**contract/
 variation,
 price request/
 instruction**

CLIENT Maniototo County Council File No. 6/6/8 Job No. 10384
 CONTRACT No. 588 - Ranfurly Reservoir and Treatment Plant No. 6
 CONTRACTOR Weir and French Ltd Date 25-2-85

**RANFURLY WATER TREATMENT STATION AND RESERVOIR
HYDRAULIC STRUCTURES AND CONNECTING PIPEWORK**

AMENDMENTS			NAME	DATE	JOB NO.	Sheet No.
NO	BY	DATE				
A	CGB	2/85	Item 28 amended, Item 20 added, 25 # arifice plate located, 250 # AC description corrected to 200 #		10384	T9A

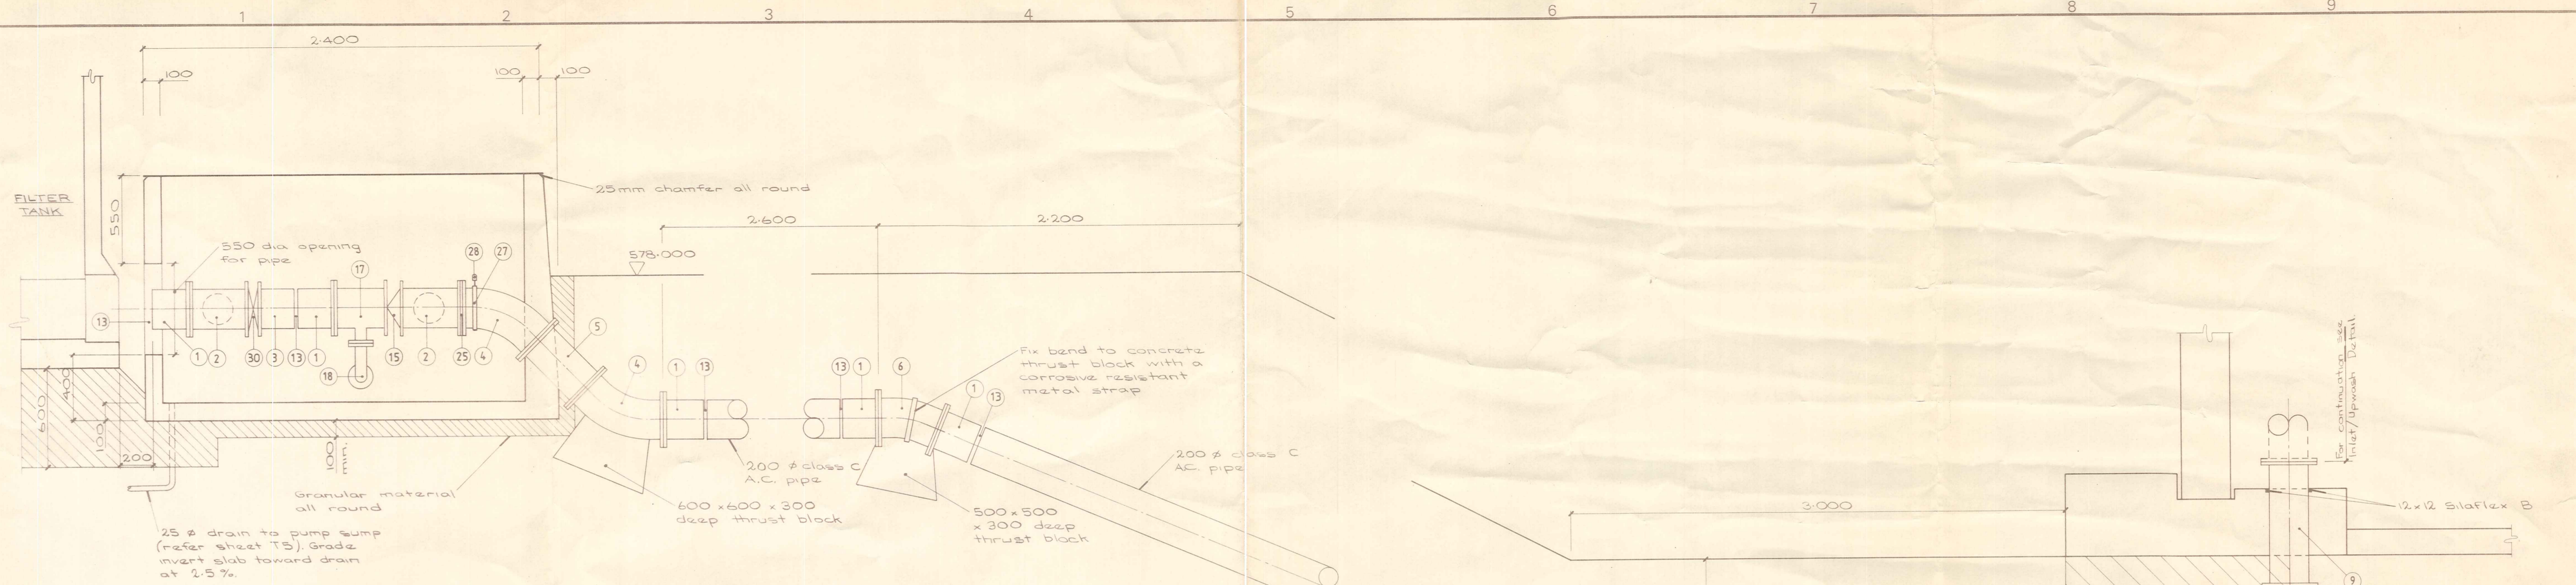
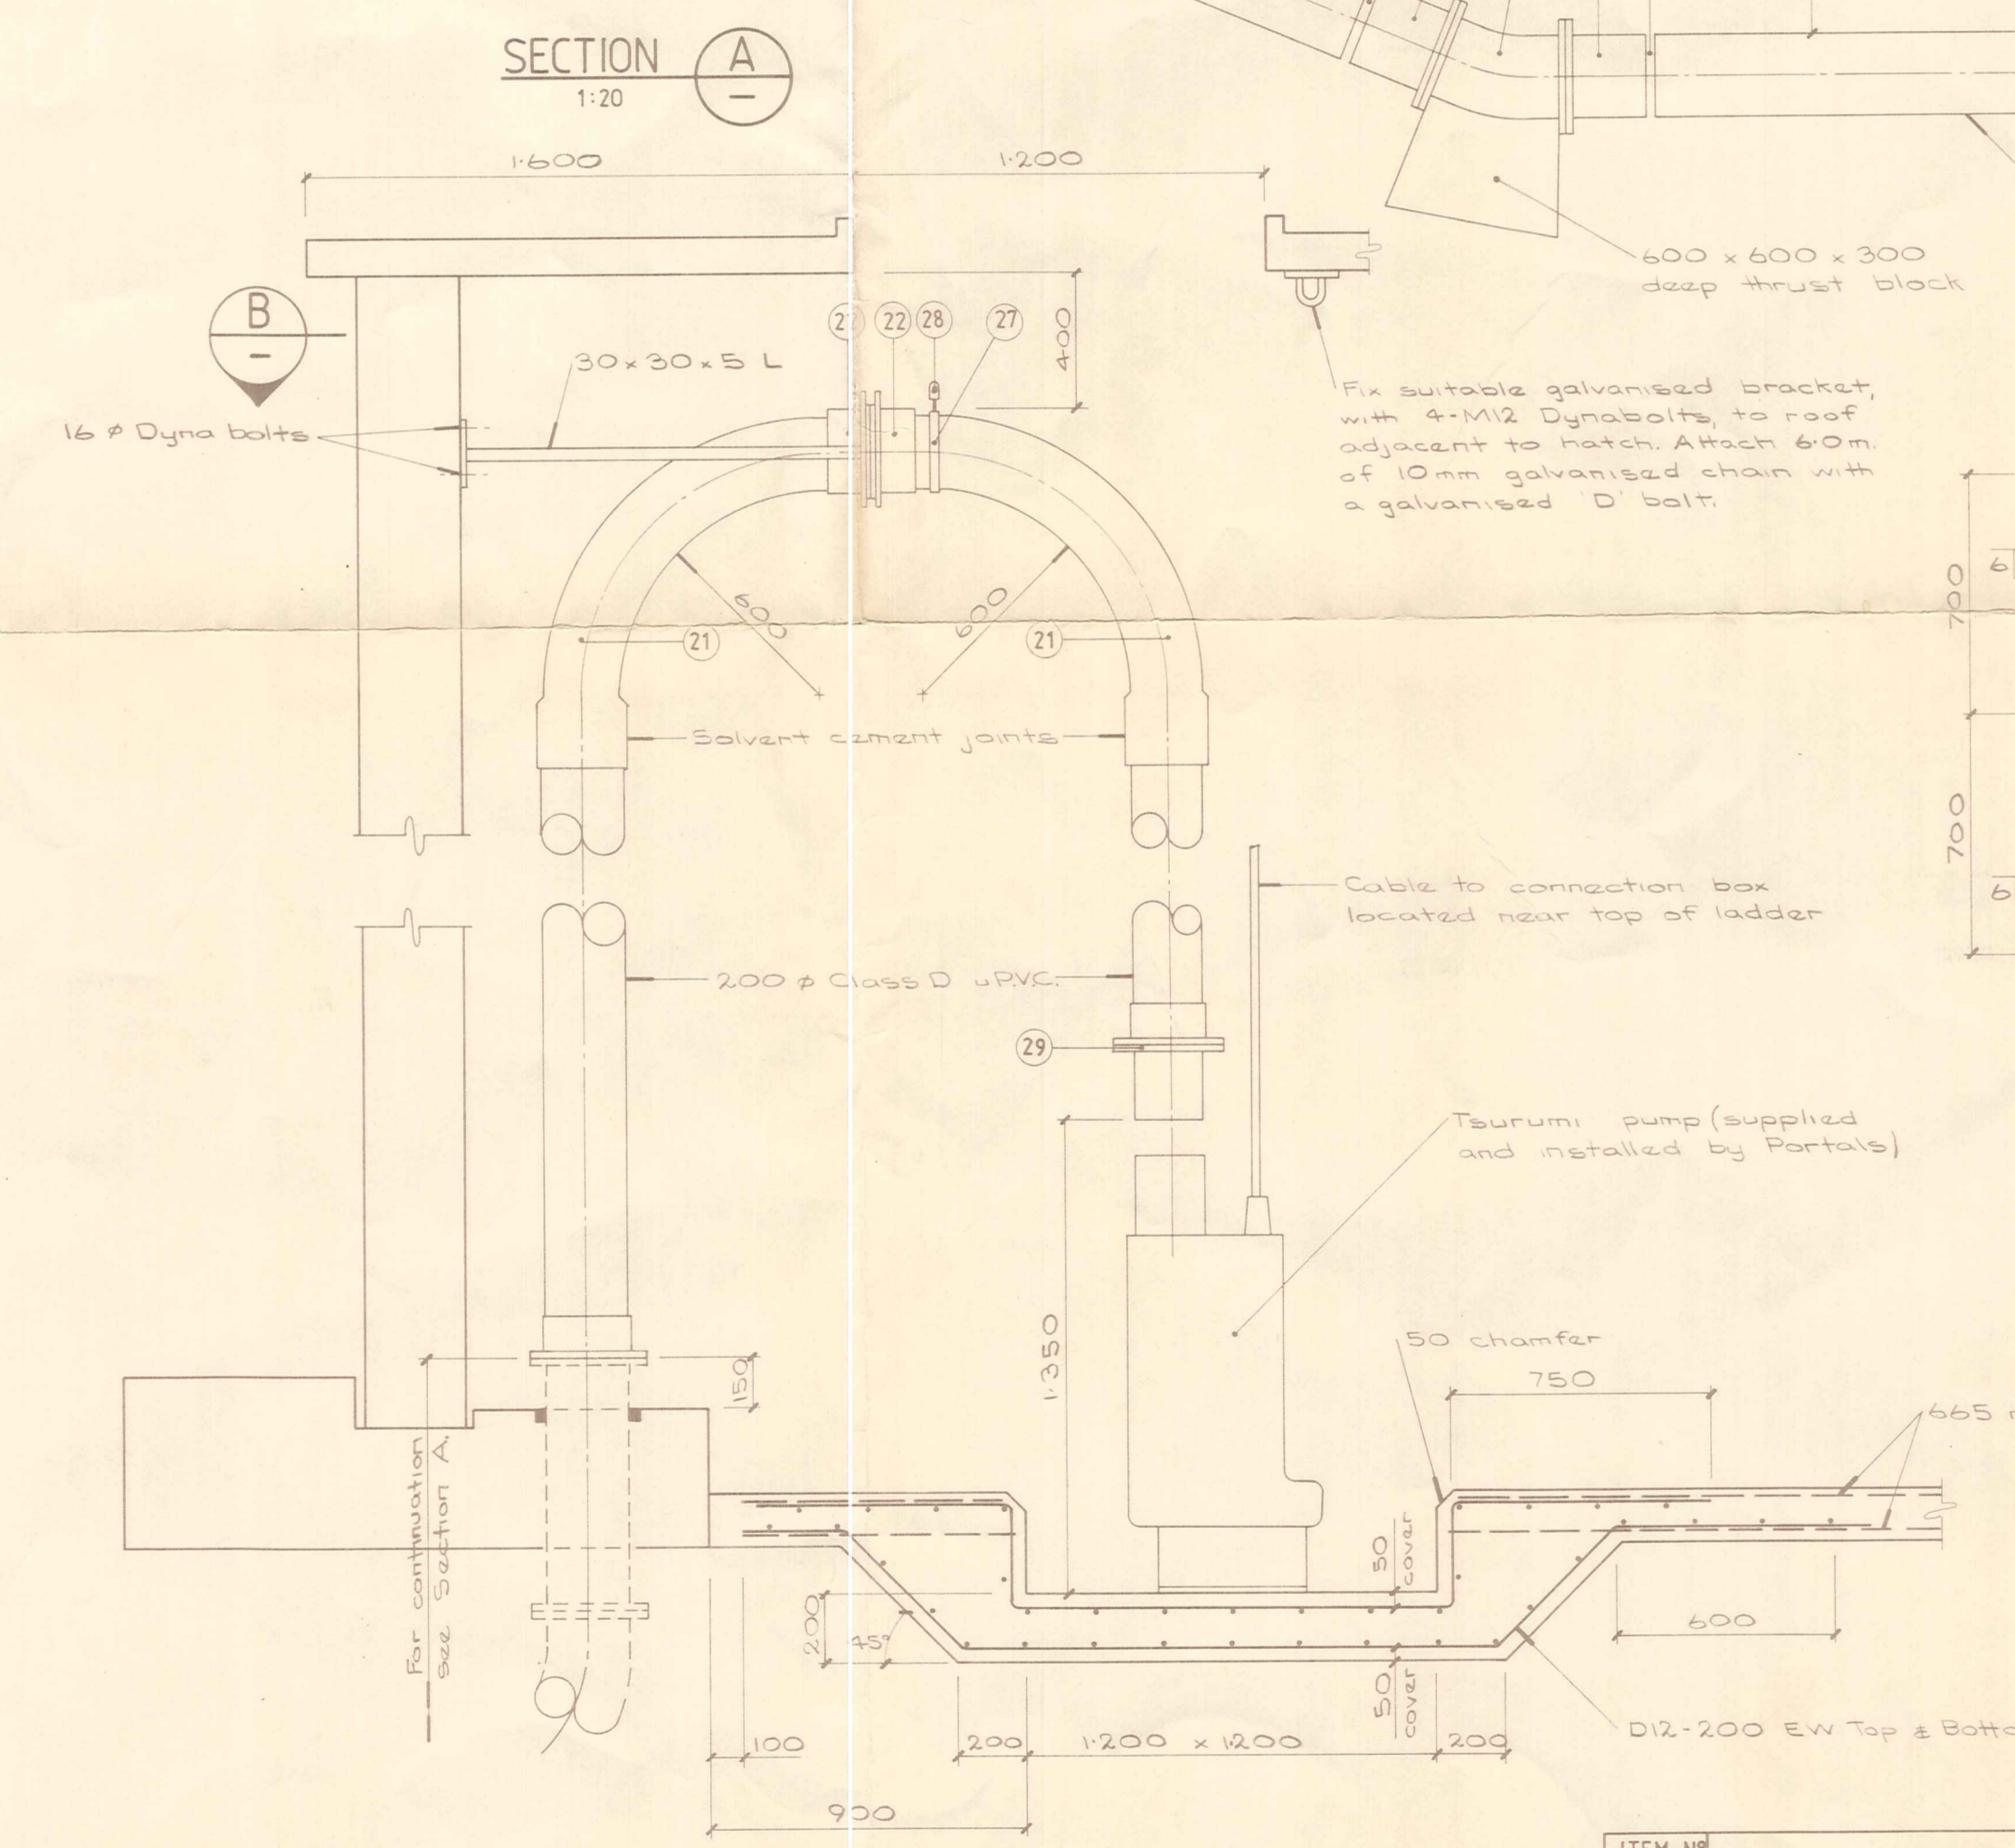
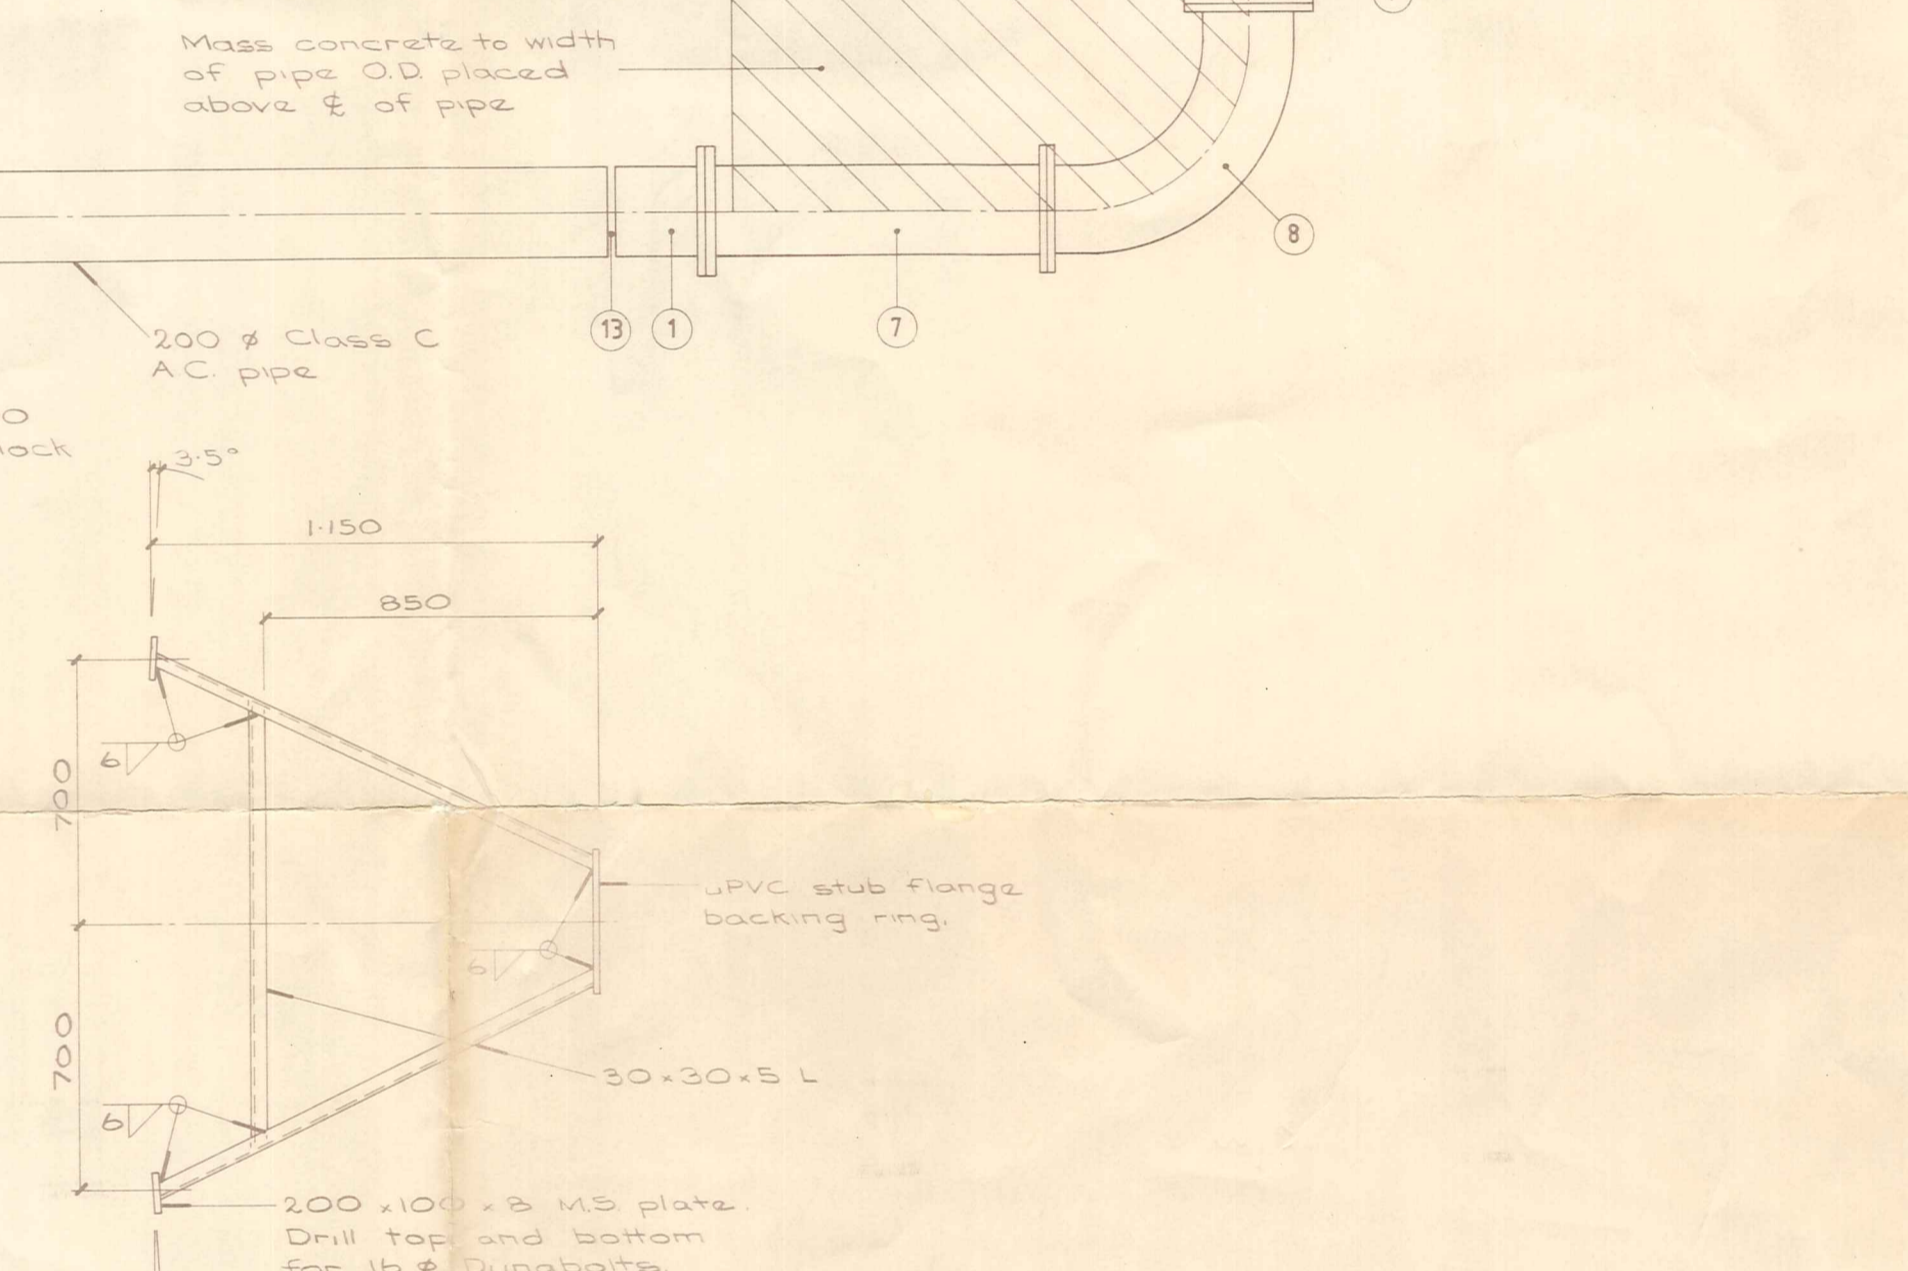
Please find enclosed Drawing 10384 Sheet 9A. The contract is ammended to allow for the installation of a 200 mm butterfly valve supplied by Portals as described on the drawing. It may be necessary to trim the adjacent cast iron straight if this has already been purchased and can not be returned to the supplier.

The location of the 25mm diameter drain as described on Sheet T5 is also described. Provide additional concrete to grade the invert slab toward the drain at 2.5%.

Item 28 is ammended from a 20mm Bermad automatic air valve to a 20mm gate valve. Please install this valve, as shown but via an elbow in order to prevent discharge toward the operator.
